UNITED STATES PATENT AND TRADEMARK OFFICE

APPLICATION NO.	FILING DATE	FIRST NAMED INVENTOR	ATTORNEY DOCKET NO.	CONFIRMATION NO.
10/809,336	03/26/2004	Cecilia DeVenezia	DV-04	9525
47728	7590	12/28/2005		
THOMAS J. GERMINARIO, ESQ. 154 ROUTE 206 CHESTER, NJ 07930			EXAMINER HAWK, NOAH CHANDLER	
			ART UNIT 3637	PAPER NUMBER
DATE MAILED: 12/28/2005

DETAILED ACTION

Jacinto et al. Figure 1

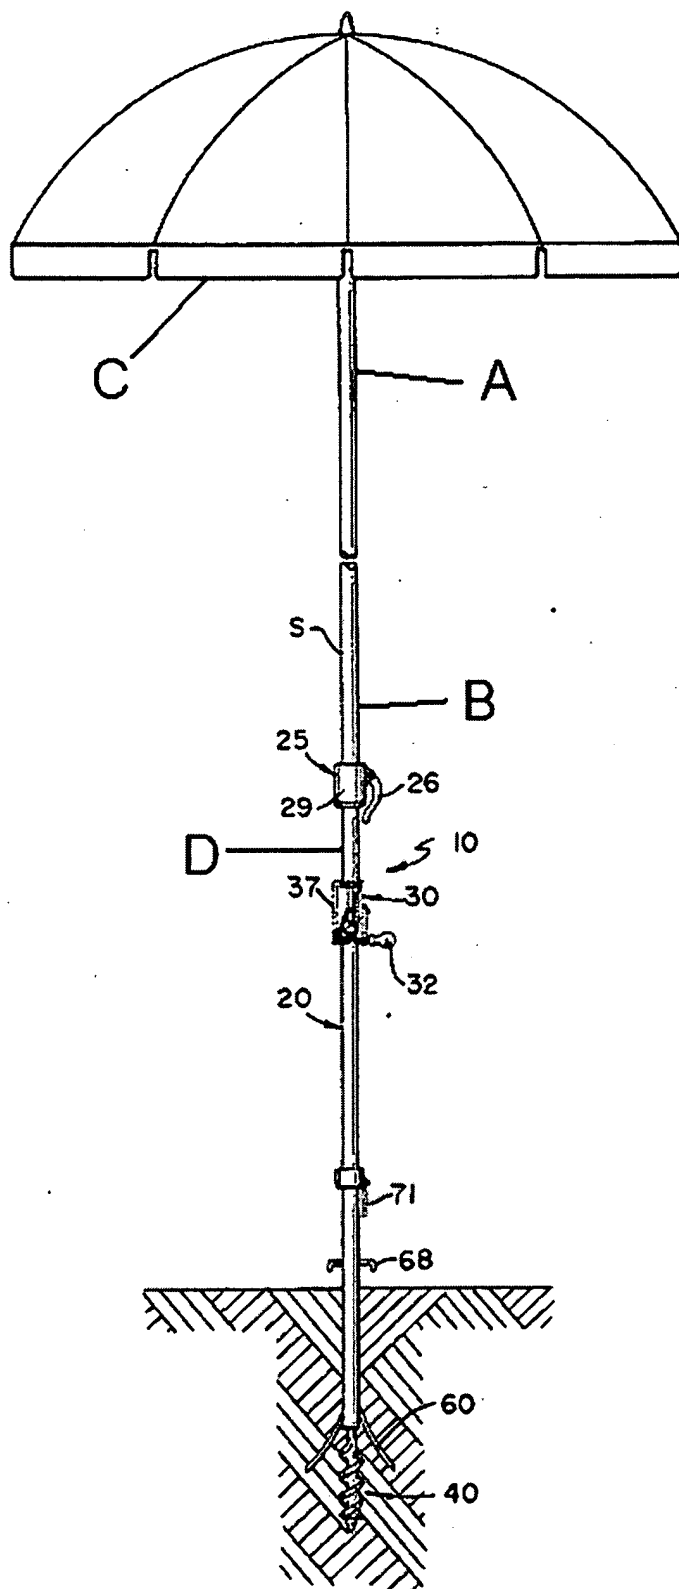
4. Claims 1-4 are rejected under 35 U.S.C. 103(a) as being unpatentable over Jacinto et al. in US Patent 5152495 in view of Doreste in US Patent 6267127 and Adams et al. in US Patent 3961671. Jacinto et al. disclose a self-anchoring beach umbrella comprising a canopy member having an upper tubular element (A), to which a spreadable canopy (C) is attached, and a lower tubular element (B); a pole member (20) having an upper element (D), a motor element (137), comprising an electric motor (80), having on its lower end an axially-disposed shaft (35) through which a rotary torque is generated when the motor is activated and an auger (40) coupled to the shaft

of the electric motor; a battery chamber (E) located in or mounted upon the pole member, said battery chamber having within it one or more batteries (90) and having a means (F) for accessing said batteries so that they may be removed and replaced or recharged; a switch (100) mounted on the motor element of the pole member and electrically connected to the batteries, whereby the motor may be activated and the direction and speed of the motor may be controlled. Jacinto et al. do not teach an axial lumen in the lower tubular element, an upper element for insertion therein, that the motor is reversible or that the device has a handle on the motor with a pressure sensitive switch. Doreste teaches a beach umbrella device with a canopy member (12) having a lower tubular element (20) within which is formed an axial lumen (26) as well as a pole member (50) having an upper element (52) formed for insertion into the axial lumen of the canopy member, but does not teach a reversible electric motor or a handle with a switch. Adams et al. teach an auger device (1) with a reversible electric motor (see Adams et al., Column 3, lines 18-21) such that the auger would rotate in a forward or reverse direction when the motor is activated. Adams et al. further teach an auger device (1) with a handle (comprising 47, 49 and 51) attached to the motor element (5) of the pole member (35), wherein the switch (57) is positioned on the handle so that the switch may be activated while a downward or upward force is applied to the handle and the switch is a positive action switch (see Adams et al., Column 3, lines 53-54 – “spring-loaded” is taken in this case to mean that it springs back to the “off” position when pressure is not constantly applied) such that the switch is not activated unless a continuous pressure is applied thereto. It would have been obvious to one of ordinary

skill in the art at the time of invention to modify the device of Jacinto et al. by using a reversible electric motor and adding a handle and placing a positive action switch on it as taught by Adams et al. in order to make the machine easier to control and to "rotate in reverse and... back the anchor out" (see Adams et al., Column 5, lines 20-21) and to use an axial lumen in the lower tubular element to receive an upper element formed for insertion therein as taught by Doreste in order to allow the canopy member to be more easily separated from the pole member.

Campomar, Figure 3

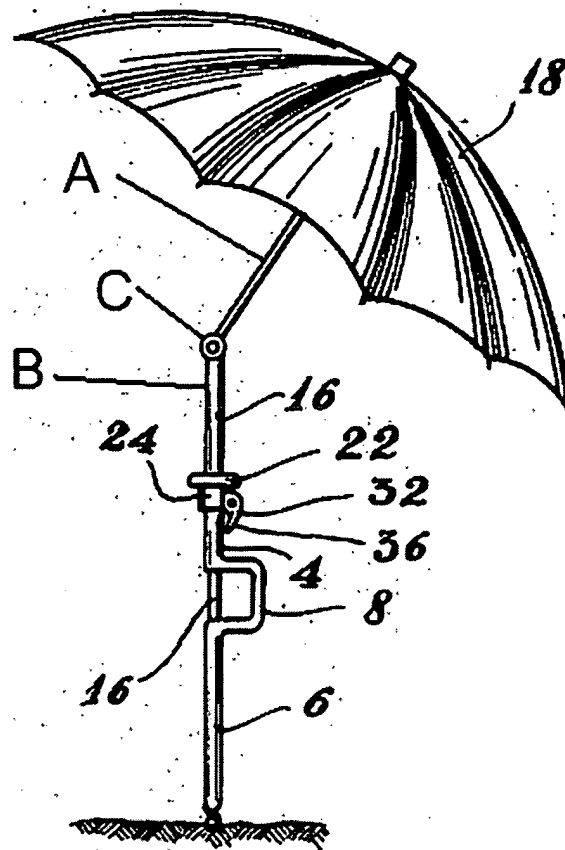
8. Claim 7 is rejected under 35 U.S.C. 103(a) as being unpatentable over Jacinto et al. in view of Doreste and Adams et al. as applied to claims 1-4 above, and further in view of Campomar in US Patent 2628797. As stated above, Jacinto et al. in view of Doreste and Adams et al. teaches all of the limitations of Claim 1-4 including an augur-anchored beach umbrella, but does not teach a tilting umbrella. Campomar teaches an auger-anchored umbrella with a joint means (C) disposed between the upper (A) and lower (B) tubular elements for tilting the upper tubular element of the canopy about an axis with respect to the lower tubular element. It would have been obvious to one of ordinary skill in the art at the time of invention to modify the device of Jacinto et al. in view of Doreste and Adams et al. by using a tilting umbrella as taught by Campomar in order to change the position of the umbrella without changing the anchor position.

Campomar teaches an auger-anchored umbrella with a joint means (C) disposed between the upper (A) and lower (B) tubular elements for tilting the upper tubular element of the canopy about an axis with respect to the lower tubular element. It would have been obvious to one of ordinary skill in the art at the time of invention to modify the device of Jacinto et al. in view of Doreste and Adams et al. by using a tilting umbrella as taught by Campomar in order to change the position of the umbrella without changing the anchor position.

19. In response to the applicant's argument that Campomar does not teach a jointed, tilting umbrella, the applicant is directed to Campomar, Column 1, lines 16-17 "Such stem is often jointed to allow of positioning the shade at a variable angle." In addition, the Office directs attention to Campomar, Figure 3 as modified by the examiner *and included in this and the previous office action*. The tilting joint is clearly labeled with the reference letter "C."

Fig. 1

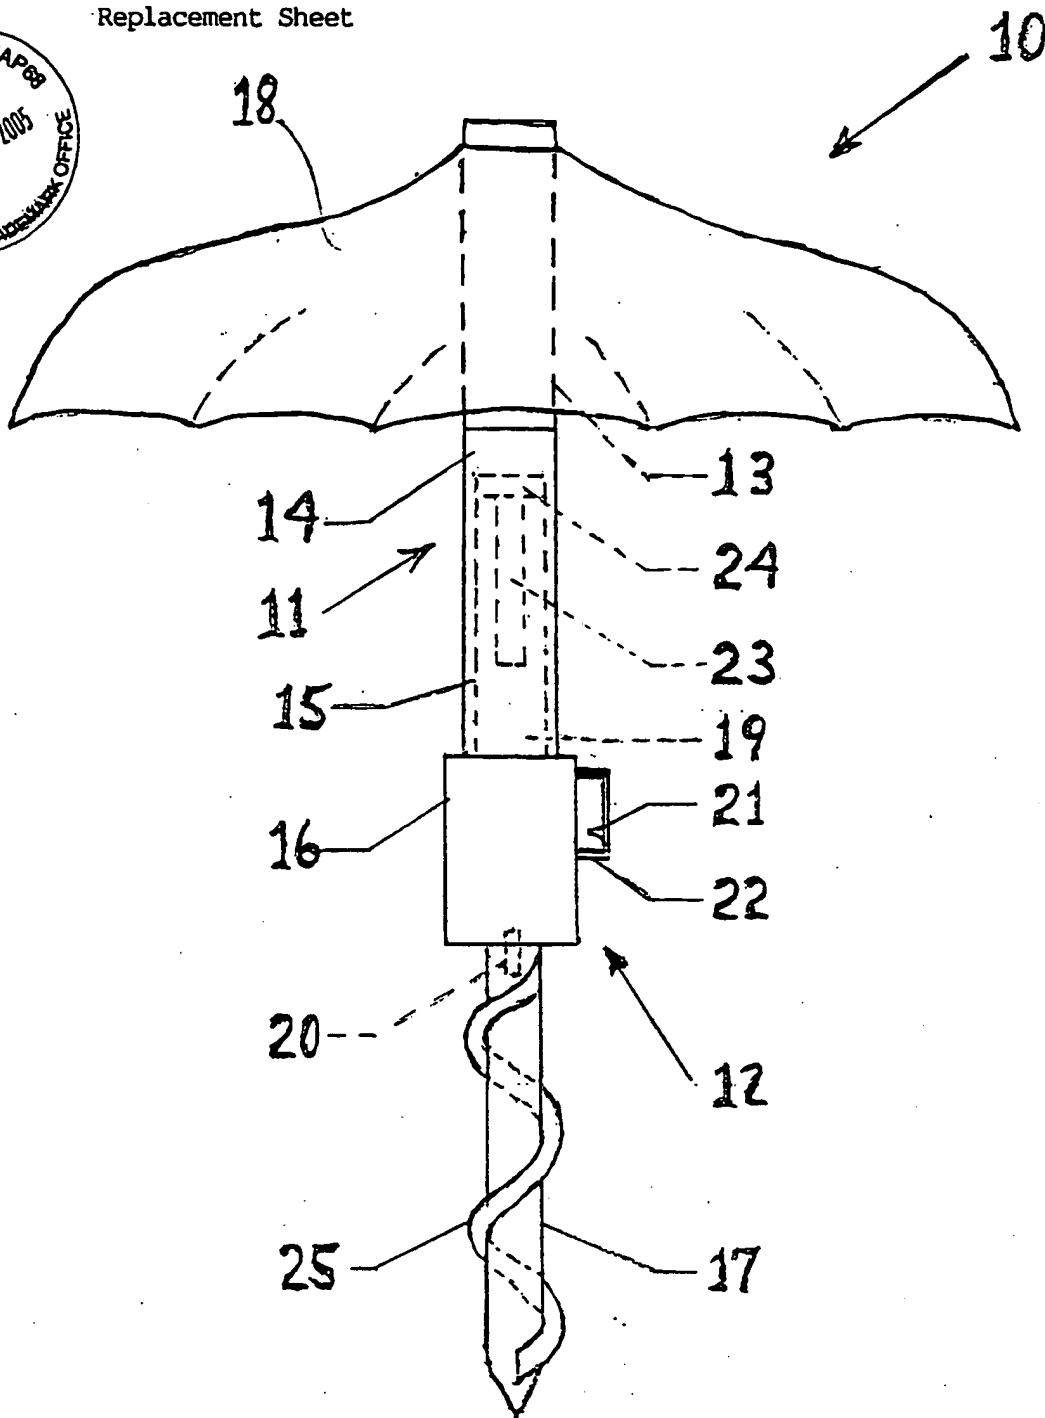
2. The replacement drawings were received on 11/2/05. These drawings are acceptable.

Accepted
NCH 12/16/05
